HCW/15/18
East Devon Highways and Traffic Orders Committee
5 March 2015

### Speed Cushions, West Hill Road, West Hill

Report of the Head of Highways, Capital Development and Waste

# Highways Act 1980 - Section 90A Speed Cushions – West Hill Road, West Hill, Ottery St Mary

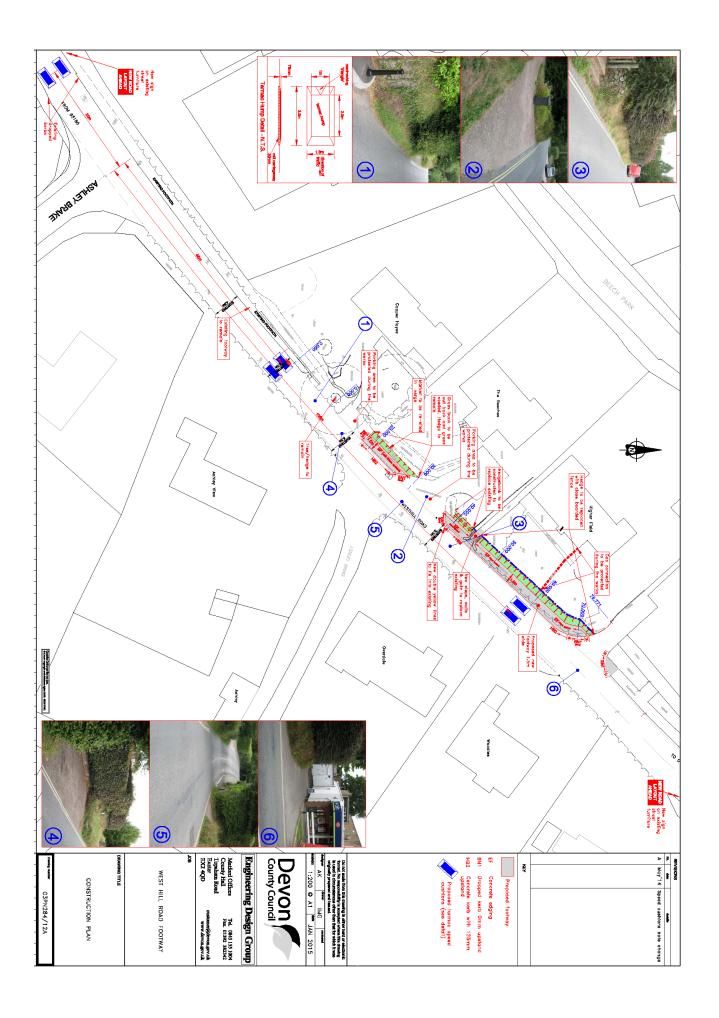
Comment	Response
First Respondent: Resident, Ashley Brake	k =
Every vehicle will speed up when they leave each speed cushion which will increase noise and air pollution and affect pedestrians in West Hill Road.	Page 5 of Traffic Advisory Leaflet (TAL) 4/94 suggests that there is little variation in noise if the cushions are spaced to allow an average of 20mph speed along the route.
As residents they will become more aware of traffic	See above.
noise and is an example of unintended consequences.	occ above.
Lived in the village for over 26 years (and at current address for 13.5) and not aware of any accidents in the area.	No recorded collisions in past 5 years.
Was not directly consulted and only became aware of proposals by notice on-street.	Consultation process included in the HATOC report.
Traffic may be slowed but in doing so will generate more noise from brakes, vehicle engines, gear changes and damage suspension for vehicles driving over them. Increasing environmental harm to road users.	Page 5 of TAL 4/94 suggests that there is little variation in noise if the cushions are spaced to allow an average of 20mph speed along the route.

Cyclists would find the cushions a hazard in the dark.	Cushions would be marked appropriately an in line with relevant regulations and guidance.
Ambulance and mini bus journey would be more uncomfortable (65% of the village is retired).	The scheme has been designed based on guidance from TAL 4/94 and 1/98, which considered the advice of the emergency services.
Where such schemes have been progressed elsewhere, the condition of the road surface around the cushions has deteriorated requiring ongoing repairs.	Road condition will continue to be monitored by the DCC Safety Inspection Policy.
Second Respondent: Resident, West Hill Road	
<ul> <li>Would like additional speed bumps lower down West Hill Road opposite Toad Pit Lane:</li> <li>It is a blind corner and tractors regularly exceed 40mph (it is a 20mph limit).</li> <li>Bus stops on both sides of the road. High chance of speeding cars meeting a stationary bus.</li> <li>There are large heavy vehicles speeding along the road which require long braking distances.</li> <li>School buses pick up &amp; drop off children from the junction and speeding vehicles present a danger to these children. So the 20mph needs to be enforced.</li> <li>There will be a new driveway onto West Hill Road creating a further hazard to speeding cars.</li> </ul>	Comments noted.

Comment	Response
There has been a speed limit on West Hill Road for	The scheme has been designed based on
some time and speed cushions will not slow the	guidance from TAL 4/94 and 1/98, which
'wide-track' heavy commercial vehicles or	considered the advice of the emergency services.
motorcycles. These types of traffic regularly use the	Ŭ,
road as a shortcut into Ottery St Mary. Suggest a	
weight restriction.	
What traffic may be slowed by speed cushions will	Page 5 of TAL 4/94 suggests that there is little
create a greater level of noise.	variation in noise if the cushions are spaced to
	allow an average of 20mph speed along the route.
What traffic may be slowed will both create and	A safer route to the school for pedestrians and
spread greater pollution?	cyclists could potentially have a positive
	environmental impact.
No consultation with local residents.	
Concerned that new footpath, that forces pedestrians	Noted.

to leave the pavement to negotiate the beech tree,	
will not improve safety for pedestrians, particularly	
children.	Will not receive the incur of vehicle anced in the
Suggests removing the tree or turn the path through the hedge into the village hall car park to take school	Will not resolve the issue of vehicle speed in the 20mph zone.
children directly to school and onto the store/post	Zompri zone.
office.	
Fourth Respondent: Ottery St Mary Town Council	1
Fully support the construction of the new footway.	Noted.
This will reduce the width of the road and, with	This was not the advice of the safety audit.
appropriate road markings and signage, should slow	
traffic down. The use of speed cushions in this	
location will seem completely superfluous.	
Strenuously oppose the proposed speed cushions or	Noted.
any form of obstruction to the highway.	
After some internet research it would seem that	
speed cushions are losing favour with many

authorities in many countries for the following	
reasons.	Funded through LTD scheme
<ul> <li>Cost (installation and ongoing maintenance)</li> <li>Little evidence of effectiveness.</li> </ul>	Funded through LTP scheme Studies have shown that changes in speed are
	related to changes in accidents, with a 1 mph
Evidence shows no accident reduction.	reduction in speed giving a 5% reduction in
	accidents
Dangerous to cycles and motorcycles due to	The DfT considered designs for speed cushions
sloped sides.	should accommodate all road users safely. Trials
Sloped Sides.	were undertaken to determine design parameters
	of cushions that might be suitable for use on
	public roads. The results of these trials are
	documented in TRL Report PR 32 and have been
	considered in the design.
Invisible when covered with snow.	Travel speed would be appropriate to conditions.

• Increased exhaust noise, brake squealing and	DfT Document TAL 4/94 states "the presence of a
bangs from lorries.	speed cushion can result in a substantial drop in
	traffic noise levels. The maximum vehicle noise
	for light vehicles can also be reduced, as a result
	is inglif to include call allow no reduced a, as a recall i
	of light vehicles slowing down at the cushion".
	of light vehicles slowing down at the cushion". The cushions within the scheme are spaced so
	of light vehicles slowing down at the cushion". The cushions within the scheme are spaced so that constant traffic speeds, averaging 20mph or
	of light vehicles slowing down at the cushion". The cushions within the scheme are spaced so that constant traffic speeds, averaging 20mph or less, are encouraged along the route.
Traffic will use less suitable routes to avoid cushions.	of light vehicles slowing down at the cushion". The cushions within the scheme are spaced so that constant traffic speeds, averaging 20mph or

Comment	Response
Added pollution from accelerating vehicles and brake/tyre dust.	DfT document TAL 4/96 suggests the considerable increase in NOx suggested by certain road hump experiments abroad is unlikely to occur. This is because the harsh acceleration and deceleration modelled in these experiments is not typical of the driving habits generally adopted. The spacing of cushions in this scheme is based on the best practice guidance.  Designed in line with the advice in TAL 1/98 and
<ul> <li>Damage to tyres.</li> <li>Cushions require adequate lighting (although lighting is not mandatory in this case as 20mph</li> </ul>	4/94 which takes such factors into account.  Answered in statement.
zone).  • If measures are considered necessary, would prefer a rumble strip.	The noise impact on residents would be greater and the impact on vehicle speeds less effective.
Fifth Respondent: Resident, West Hill Road  Property is in the vicinity of one set of the proposed cushions.

Speed of traffic along West Hill Road is frequently in excess of the 30mph & 20mph limits. Therefore supports attempts to reduce the speed of traffic through the village.	Noted.
Understands that some studies show speed cushions result in little change in noise levels, but convinced that the existence of cushions may increase traffic noise, in particular as traffic slows and accelerates over the cushions. Any additional noise would be intrusive and directly affect the properties.	Page 5 of TAL 4/94 suggests that there is little variation in noise if the cushions are spaced to allow an average of 20mph speed along the route.
Would strongly object to the cushions if they require to traffic to almost stop to proceed over them as this would have a significant effect on noise and emissions.	The cushions within the scheme are spaced so that constant traffic speeds, averaging 20mph or less, are encouraged along the route.

Trusts that the design (in particular the width) will prevent larger vehicles (4x4s, SUVs & vans) placing wheels either side of the cushion, thus negating the need to slow down.	The design is based on allowing buses and emergency vehicles along this route and hence has been designed at 1.6m width, based on guidance form TAL 4/94 and 1/98.
As there is a footpath being built, this will make it safer and asks if this has been considered with regard to the proposed cushions.	The safety audit recommended the introduction of traffic calming as unfortunately the required land could not be obtained to complete this section of footway.
Concerned that the excessive speed of traffic approaching the supermarket will be unaffected by this proposal.	This scheme is targeted at the section of West Hill Road within the 20 mph zone.
Concerned that traffic control measures such as speed cushions try to balance competing objectives and their effectiveness may be compromised.	Noted.

Suggests a village wide approach to speed control that might be more effective than physical measures in a residential area.	This scheme is targeted at the section of West Hill Road within the 20 mph zone.
Council needs to consider current and future volumes of traffic through the village.	Noted.
The volume of traffic must affect the number of speeding incidents. It is clear that West Hill Road is used by motorists and commercial vehicles using it as a short cut to Ottery St Mary and has increase significantly in the last 20 years.	The introduction of traffic calming may make this a less attractive short cut option.
Traffic is likely to substantially increase with developments in West Hill and Ottery St Mary.	Noted.

Comment	Response
West Hill Road is narrow with poor visibility at points and little footpath. The road is not suitable for the amount and speed of traffic currently using it, let alone any increase.	
In summary believes that road safety issues arise from speed and volume of traffic in West Hill and that interventions should be considered on a village wide basis.
